Subject: AP1000 Response to Request for Additional Information (SRP 12)

RAI-SRP12.3-CHPB-02

# AP1000 TECHNICAL REPORT REVIEW

RAI Response Number: RAI-SRP12.3-CHPB-02

Figure 1.1 - Dimensions Associated with AP1000 Fuel Handling

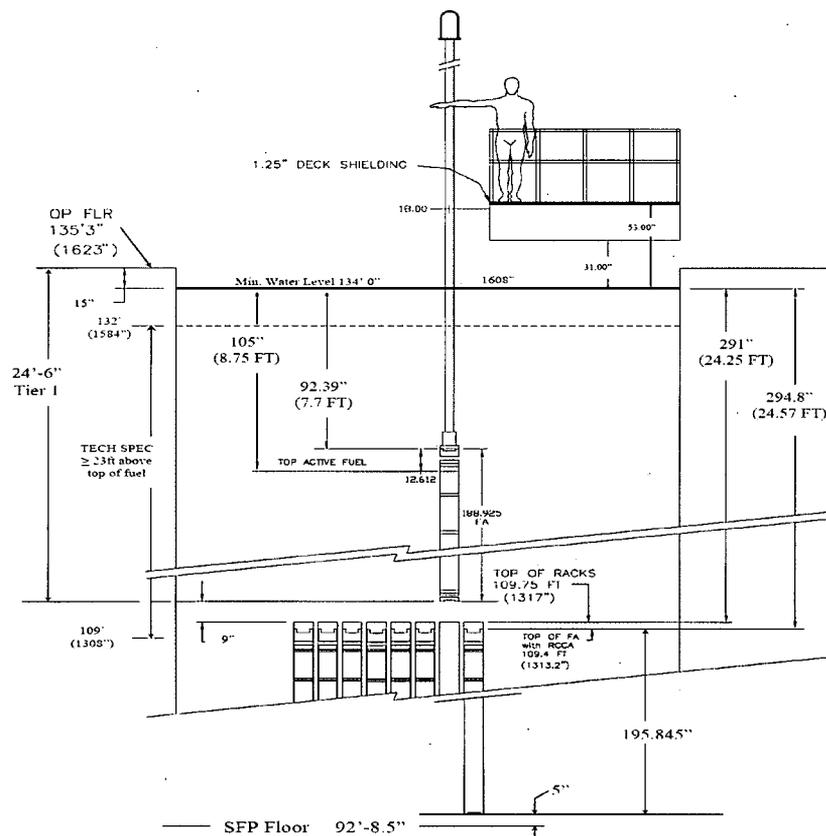
In AP1000 DCA, Revision 17, Tier 2 DCD Section 12.3.2.2.4, Fuel Handling Area Shielding Design, the applicant decreased the overall minimum allowable water depth above active fuel in the reactor cavity and spent fuel pool from 9.5 feet (Revision 16) to 8.75 feet in Revision 17 during fuel movement. With the reduction in the water level, the applicant did not identify the basis of its parameters included in Section 12.3.2.2.4 or why the change occurred.

Provide a complete description of the potential radiological effects and dose estimates associated with the reduction of the minimum water level over active fuel in the refueling and spent fuel pool. Include this information in the DCD and provide a markup in your response.

As shown in Figure 1.1 below, the current configuration of the SFP, fuel handling elevation, and FHM is illustrated. The minimum water coverage over active fuel during fuel handling operations is 105". The FHM operating deck where the operator stands on is approximately 53 inches above the SFP water surface (based on a minimum SFP water elevation of 134'-0"). The FHM deck thickness is 1.25" thick. This current configuration limits exposure rates to personnel on the FHM to 2.5 mR/hr or less. The configuration of the Containment Building Refueling Machine (RM) is bounded by the FHM since the RM has shielding from the mast structure and more distance from the fuel assembly to the operator.
